## 2.4 Core Cooling Systems

The information in this section of the reference ABWR DCD, including all subsections, tables, and figures, is incorporated by reference with the following departures.

Figure 2.4.1a Residual Heat Removal System (RHR-A)

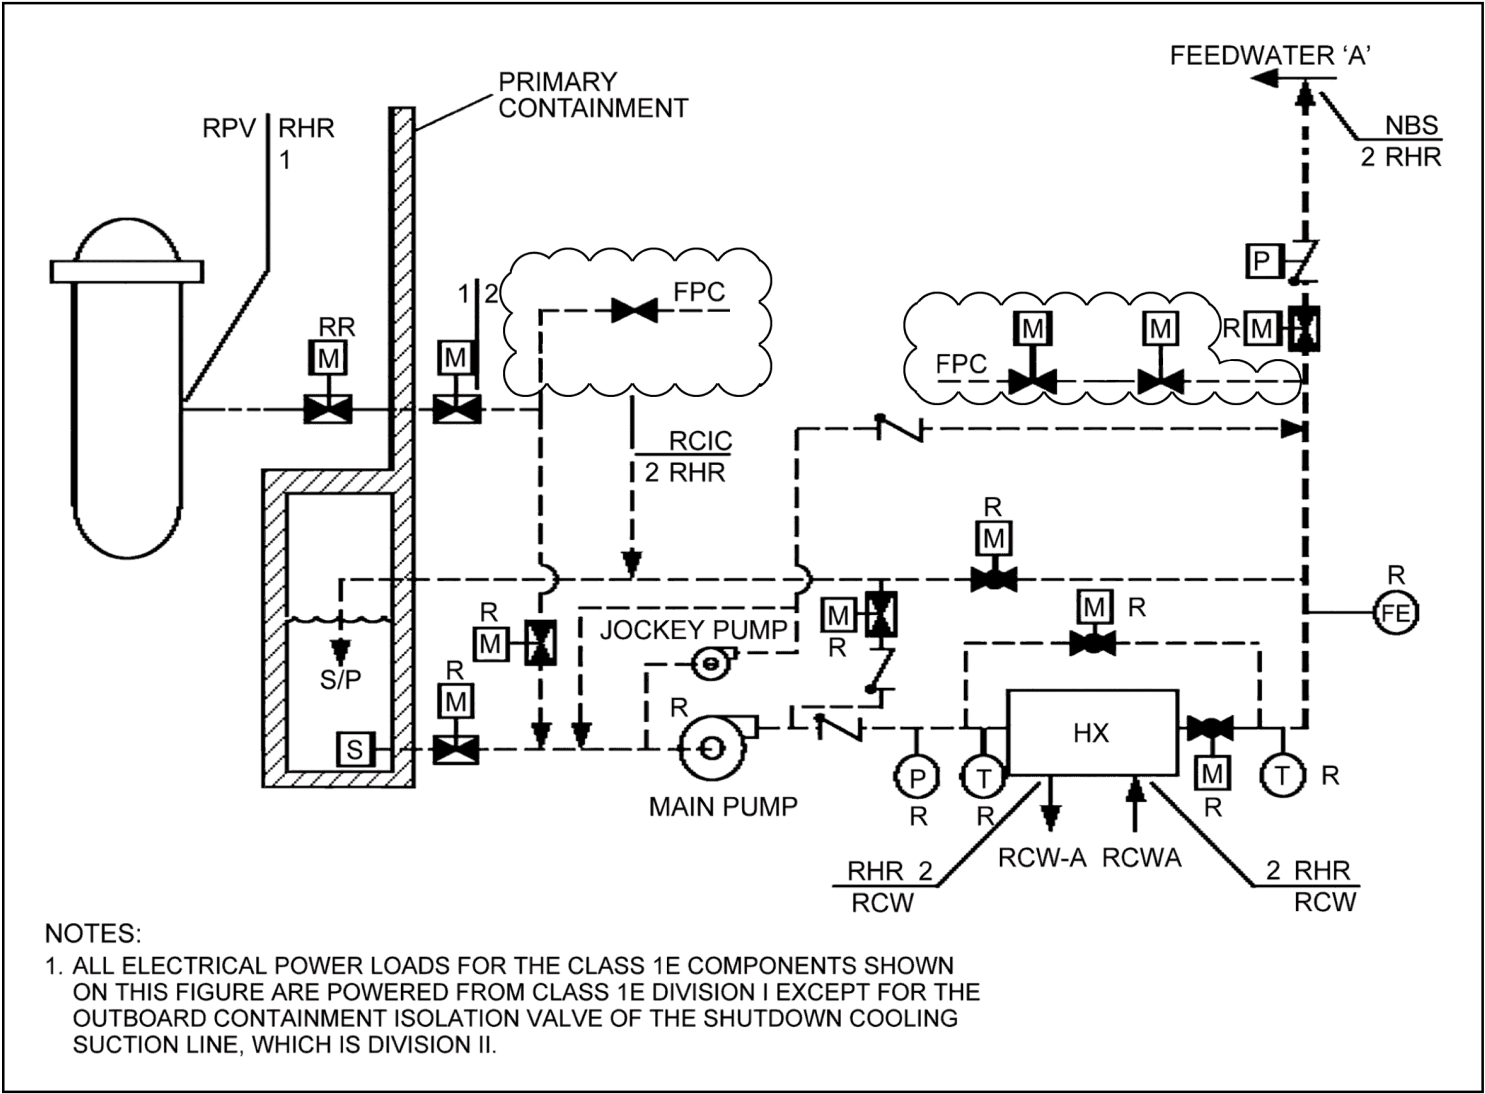
STD DEP T1 2.4-1 (Figure 2.4.1a, Table 2.4.1)

*The piping and components outside the shutdown cooling suction line containment isolation valves and outside the suppression pool containment isolation valves, and upstream of the suction side of the pump with all its branches have a design pressure of 2.82 MPaG for intersystem LOCA (ISLOCA) conditions. Refer to Figures 2.4.1a, 2.4.1b, and 2.4.1c. ~~For RHR A, the upgraded branch lines from the main pump suction include the path to and including the suppression pool suction valve, the path to the shutdown cooling outboard containment isolation valve, and the path to the jockey pump's discharge check valve including the jockey pump's bypass return line. For RHR B and C, the upgraded branch lines include all the paths listed for RHR A plus the path to (and including the valve) the Fuel Pool Cooling System that branches off~~*

~~the shutdown cooling suction line, titled "From FPC."~~ For RHR A and B, the upgraded branch lines from the main pump suction include the path to and including the suppression pool suction valve, the path to the shutdown cooling outboard containment isolation valve, the path to the jockey pump's discharge valve including the jockey pump's bypass line and the path to the (and including the valve) the Fuel Pool Cooling System that branches off the shutdown cooling suction, titled, "From FPC." For RHR-C, the upgraded branch lines include all the paths listed for RHR-A and B plus the pipeline and valves that are part of the AC independent water addition mode that extends from the noncode boundary indicated by "NNS" to the "external connection" outside the "reactor building" and to the Fire Protection System interface indicated by "FP."

Figure 2.4.1b Residual Heat Removal System (RHR-B)

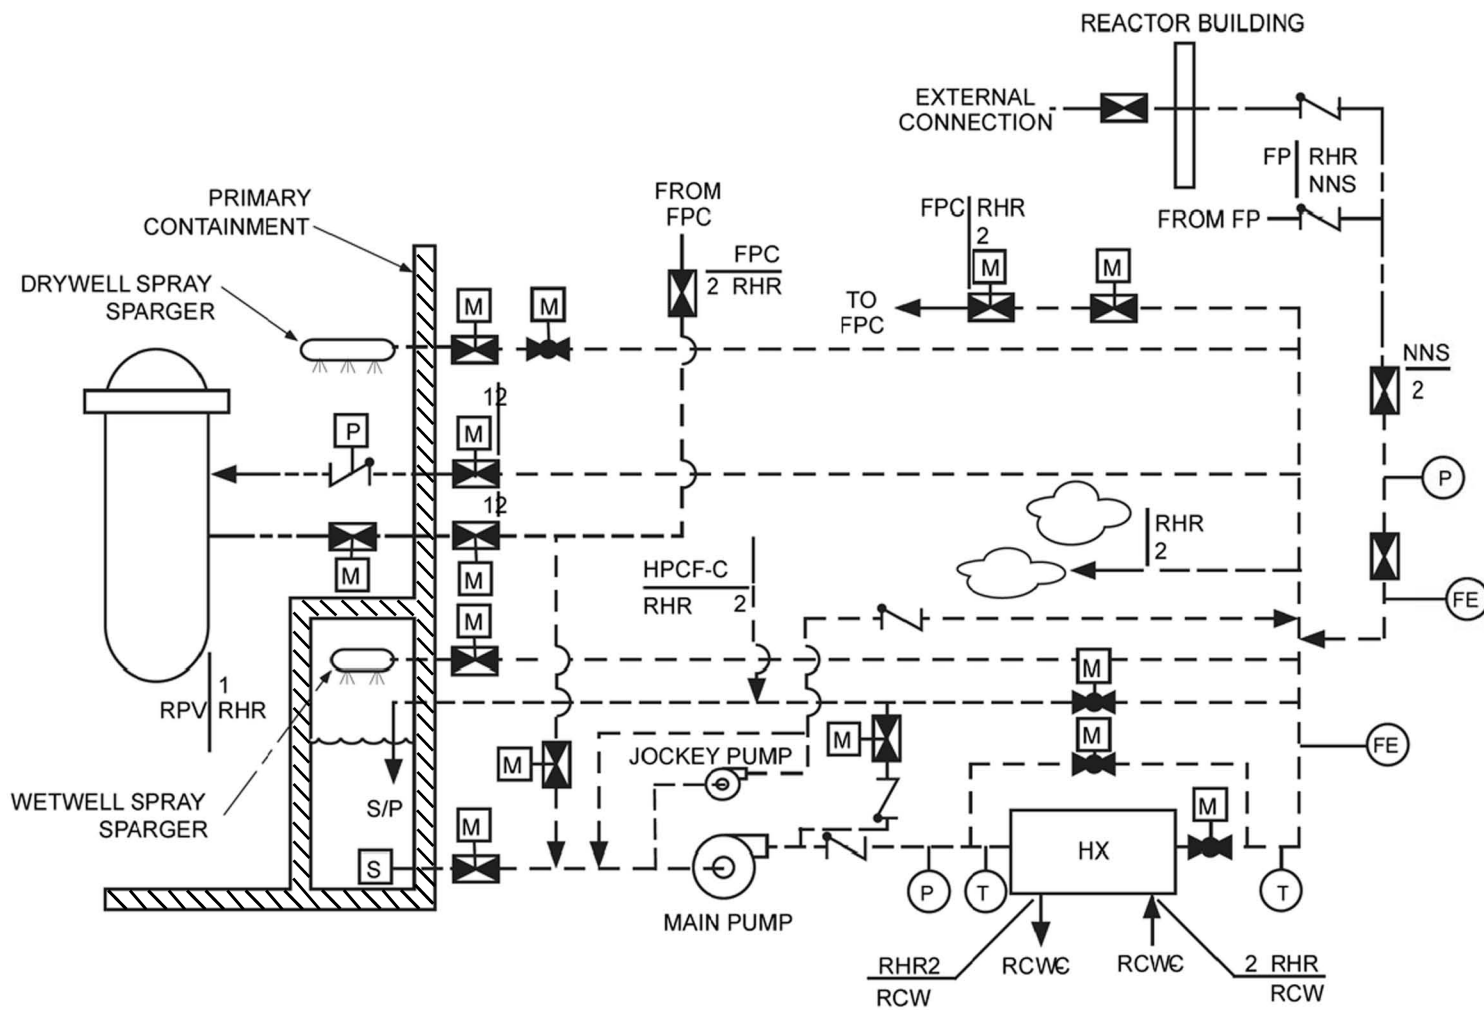
STD DEP T1 2.14-1 (Figure 2.4.1b, Figure 2.4.1c, Figure 2.4.3)

Figure 2.4.2 Leak Detection and Isolation System Interface Diagram

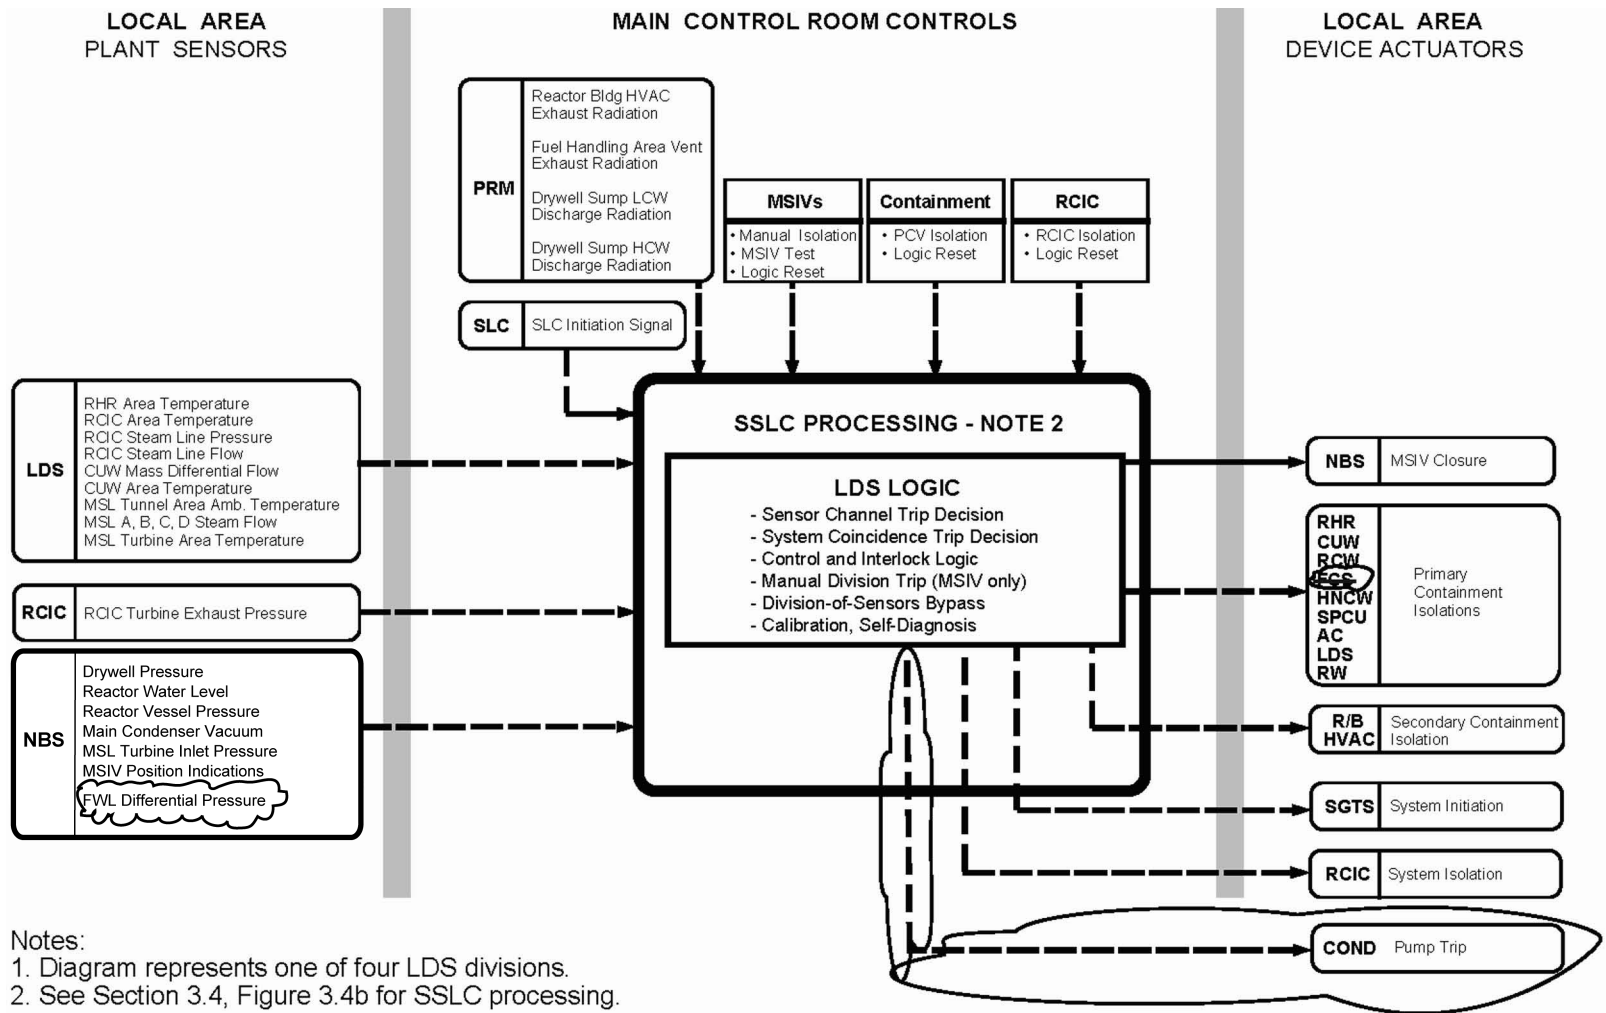
STD DEP T1 2.4-2 (Leak Detection System) Figure 2.4.3

STD DEP T1 2.14-1 (FCS, Figure 2.4.3)

- (9) *Isolation of the Suppression Pool Cleanup (SPCU) System on a signal indicating high drywell pressure or low reactor water level.*
- ~~(10) *Isolation of the Flammability Control System (FCS) on a signal indicating high drywell pressure or low reactor water level.*~~

- (10) ~~(11)~~ *Isolation of the drywell sump low conductivity waste (LCW) and high conductivity waste (HCW) discharge lines on a signal indicating high drywell pressure or low reactor water level. Also, each discharge line is individually isolated on a signal indicating high radioactivity in the discharged liquid waste; only one channel is used for this function.*

- (11) ~~(12)~~ *Isolation of the LDS fission products monitor drywell sample and return lines on a signal indicating high drywell pressure or low reactor water level.*

- (12) ~~(13)~~ *The LDS provides to the neutron monitoring system a signal indicating a high drywell pressure or low reactor water level.*
- (13) The LDS provides a trip of the condensate pumps on signals that indicate high drywell pressure and high differential pressure between the feedwater lines.

**Figure 2.4.4a Reactor Core Isolation Cooling System**

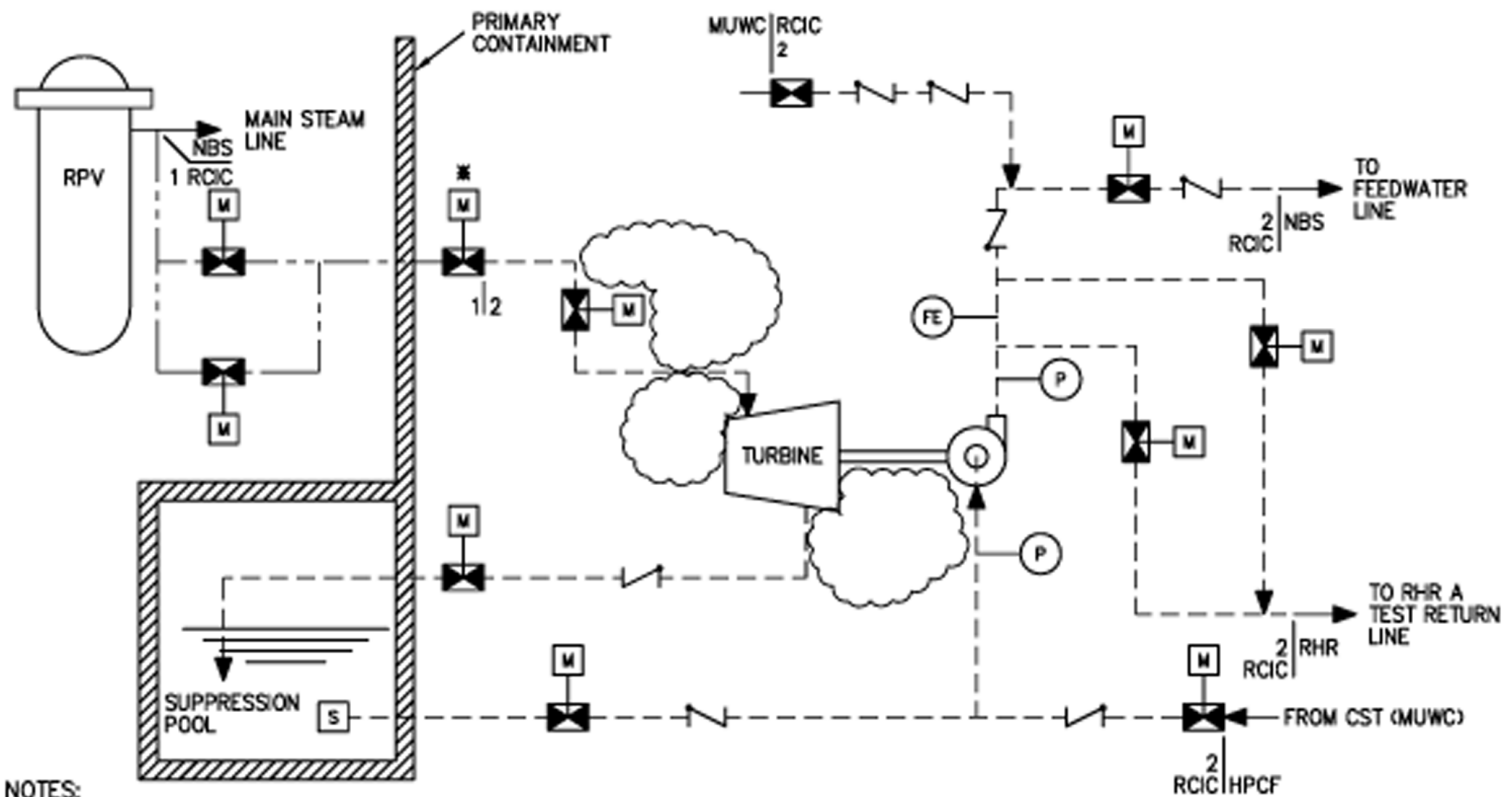
STD DEP T1 2.4-3 (Figure 2.4.4a, Table 2.4.4.)

- (1) Piping and component from the pump suction MOV's up to the pump inlet,*
- ~~(2) Barometric condenser and associated equipment.~~*

- NOTES:**
1. RCIC TURBINE IS ~~NOT COVERED BY ASME CODE SECTION II BUT IS DESIGNED, FABRICATED, AND INSTALLED TO SAFETY RELATED STANDARDS AND IS CONSISTENT WITH THE ASME CODE SECTION II REQUIREMENTS.~~ THE TURBINE INCLUDES THE TURBINE TRIP AND THROTTLE VALVE.
  2. ALL RCIC SYSTEM COMPONENTS SHOWN ON THIS FIGURE ARE POWERED FROM CLASS 1E DIVISION I EXCEPT FOR THE OUTBOARD CONTAINMENT ISOLATION VALVE (■) WHICH IS CLASS 1E DIVISION II.
  3. ALL RCIC SYSTEM COMPONENTS SHOWN ON THIS FIGURE EXCEPT THE INBOARD CONTAINMENT ISOLATION VALVES, ARE POWERED FROM DC SOURCES.
